PLANNING BOARD REPORT PORTLAND, MAINE

Three Unit Condominium
4 Russell Street
Level III Subdivision and Site Plan Review
PL-000009-2018
New Day Farm, LLC, Applicant

Submitted to: Portland Planning Board: Public Hearing Date: July 17, 2018	Prepared by: Shukria Wiar, Planner Date: July 13, 2018
--	---

Figure 4: Site Plan of Proposed Development

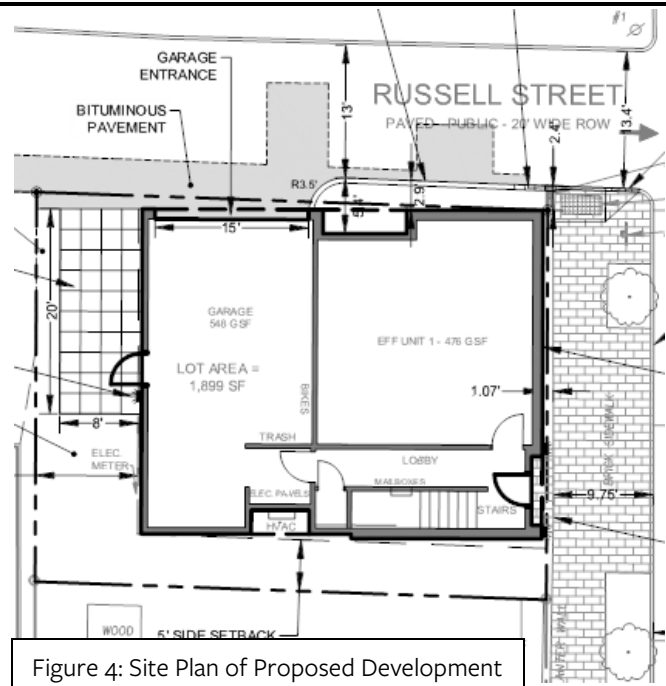
- c. Sidewalks
Currently the sidewalk along the property is in brick and the applicant is proposing to install new brick sidewalk along their frontage on Hill Street. This site is in the brick district.
 - d. Public Transit Access
The public transit requirements do not apply to this project.
 - e. Parking
There are three parking spaces and these are located inside the garage of the building. The applicant had proposed an additional parking space on the pavers at the rear of the lot, away from the main street view on Hill Street. The revised site plan notes this area as a patio but the design has not changed from the original plan. The use of this patio as a fourth parking spaces goes not meet the driveway separation requirement. Staff has recommended that this area not be used as parking and recommends a street at the Russell Street line. Mr. Errico, reviewed the plans and states:

It is my understanding that a tree or landscaping will be installed along the paved patio area thus preventing vehicle storage. I concur with this requirement and suggest a condition of approval note that vehicle storage in the patio area is not permitted.

2. Environmental Quality Standards
 - a. Preservation of Significant Natural Features
There are no known significant natural features on the site.
 - b. Landscaping and Landscape Preservation
The applicant is not proposing street trees on either Russell Street or Hill Street. According to the landscaped plan submitted, there are two existing street trees on Hill Street, of which one will be saved and one removed. Staff has recommended that a street tree be added on Russell Street at the patio location and replace the one that will be removed on Hill Street. With the installation of the two trees plus the existing one, the plan would meet City standards. The site will also have landscaping along the front of the building.

- A. To be met prior to applying for a building permit:
 1. The applicant shall submit a revised site plan for review and approval by the Planning Authority that shows two street trees shall be planted at the site; one between the patio area and Russell Street, and one to replace the tree removed on Hill Street; and

2. The applicant shall submit a revised site plan and subdivision plat for review and approval by the Planning Authority shall note that in the patio area, at the rear of the property, shall not be used as a vehicle parking space.
